Department of Environmental Quality

RE: Irigaray-Christensen Ranch In Situ Operations, Permit No. 478

I have reviewed the history surrounding the on-going excursion in the Unit 5 monitor well at the Christensen Ranch Mine, Monitor Well 5MW66.

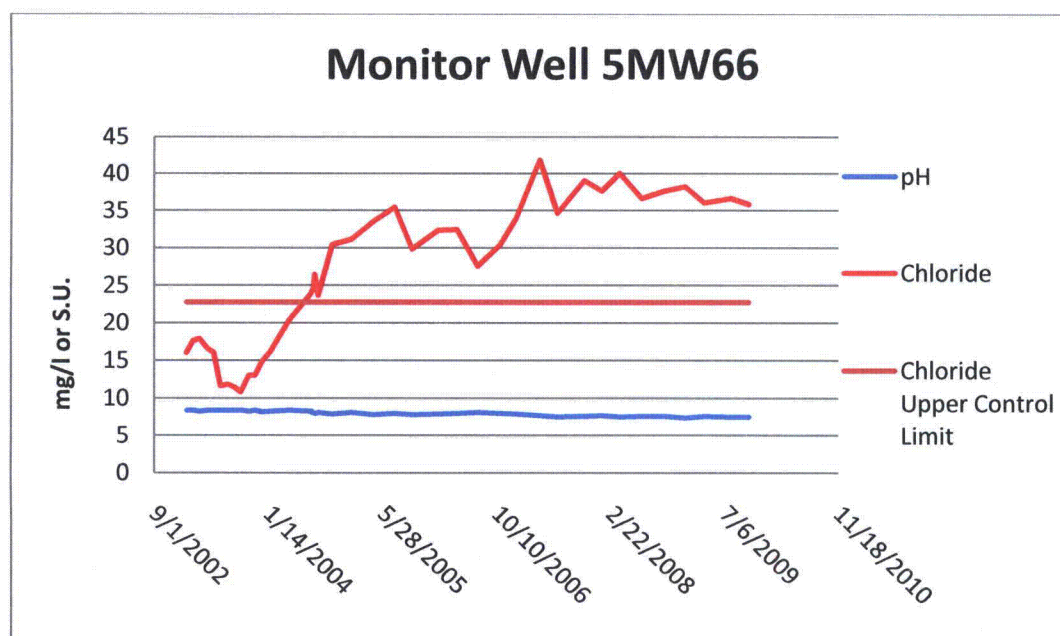
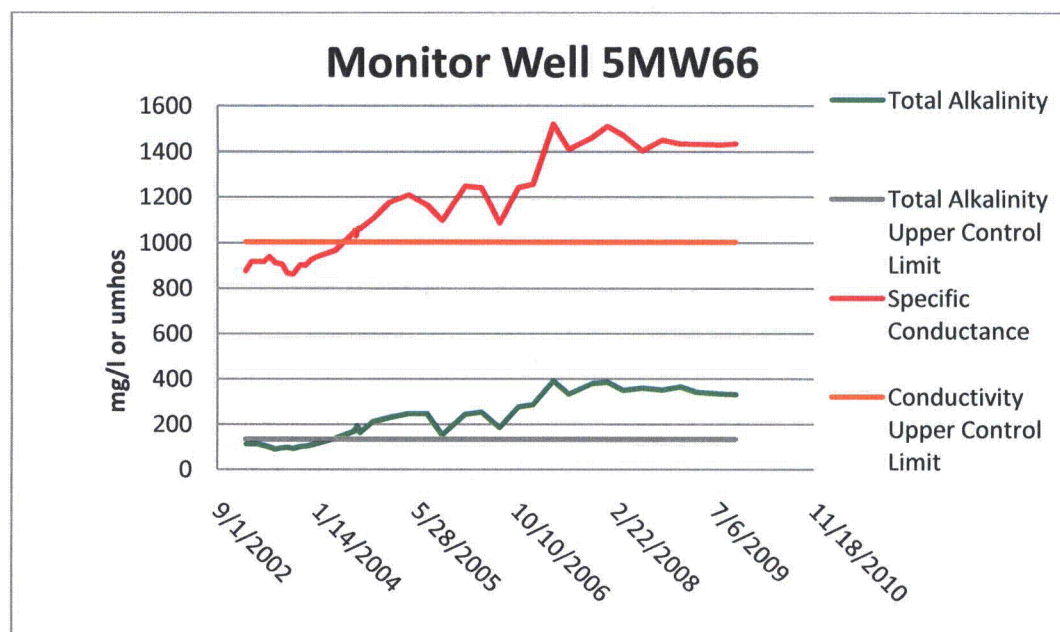
Review of the excursion parameter levels over the past seven years using data from the Annual and SemiAnnual Reports has found that the levels have leveled off, but show no hint that they may drop below the UCLs for many years. The following graphs show these levels.

In addition, it appears that uranium concentrations have dramatically increased over baseline. While no uranium or other analyses beyond the UCLs have been provided directly to WDEQ, an analysis of a sample taken September 17, 2009, was contained in COGEMA's December 30, 2009, response to Ron Linton of the NRC. This analysis showed a uranium level of 2.18 mg/l, a great increase over the 0.234 baseline mean reported back in 1995 for 5MW66 and equally great over the 0.334 mg/l reported for 5MW66 in Tom Nicholson's letter of December 9, 2009.

This increase in uranium levels, a level over seventy (70) times above the Maximum Contaminate Limit (MCL) for uranium, in a well that is located at the edge of the aquifer exemption boundary, is a major concern to WDEQ.

1. return Monitor Well 5MW66 to the list of wells on excursion status,
2. begin monitoring 5MW66 on a biweekly basis,
3. sample 5MW66 for uranium and other chemical parameters listed in Land Quality Non Coal Rules and Regulations, Chapter 11, Section 12(d)(i) in addition to the excursion parameters,
4. present a plan and compliance schedule for controlling the excursion as outlined in Land Quality Rules and Regulations, Chapter 11, Section 12(d)(iii),
5. report the status of 5MW66 as required by Land Quality Rules and Regulations, Chapter 11, Section 12(e)(i),(ii) and (iii).
